TRANS/WP.29/GRSP/2001/23
20 September 2001

PROPOSAL FOR DRAFT 05 SERIES OF AMENDMENTS TO REGULATION No. 16
(Safety-belts)

Transmitted by the Experts from Japan and Spain

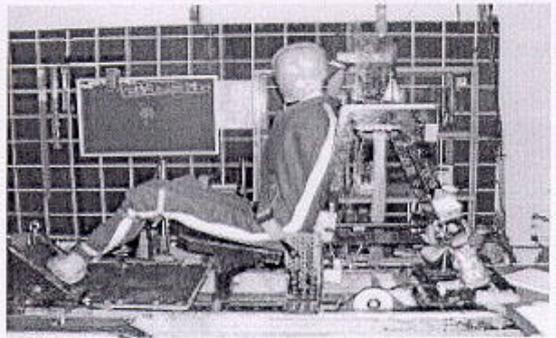
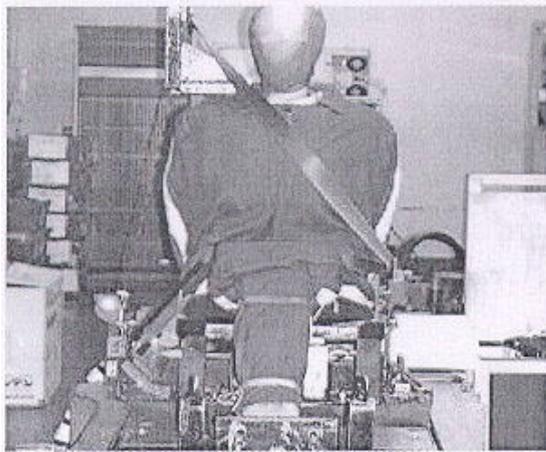
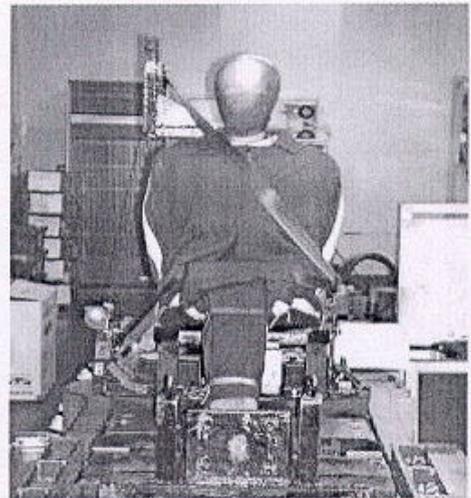
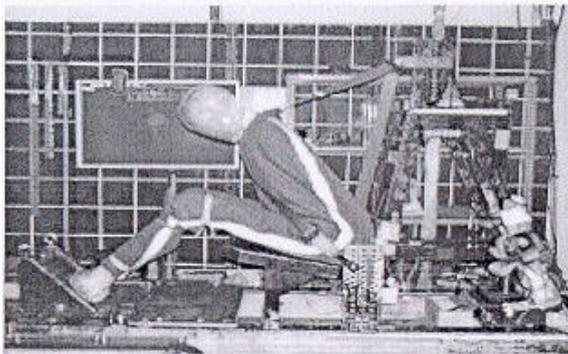
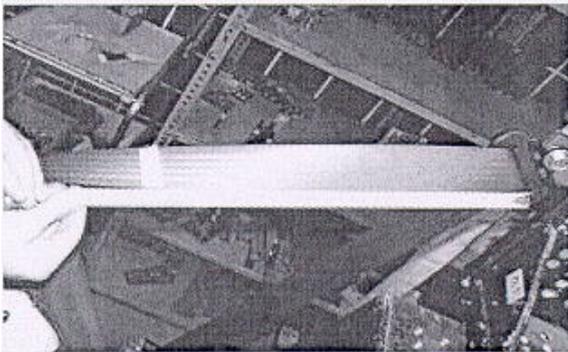
In addition, the adopted procedure was changed from "the dummy is tilted 45° frontward" to "the seated dummy shall be tilted frontward until 350 mm of the strap is withdrawn from the retractor", because the tilt angle is not easy to measure on the dummy. Judging from our test results, the strap-withdrawn length of 350 mm is enough to make the equivalent result as dummy tilt angle of 45° (please see attached reference data).

It is difficult to determine the reference point of the tilt angle for the dummy. This is as the front of the torso has a spherical contour, and the back against the seat prevents attachment of the inclinometers. So the measurement procedure is not stabilized.

Table A shows the length of strap withdrawn is less than 350 mm for all vehicle models. Therefore, 350 mm is the appropriate length to be used.

"7.6.4.2. Before the dynamic test described in paragraph 7.7. the seated dummy shall be tilted frontward until 350 mm of the strap is withdrawn from retractor, and then released to the initial position."
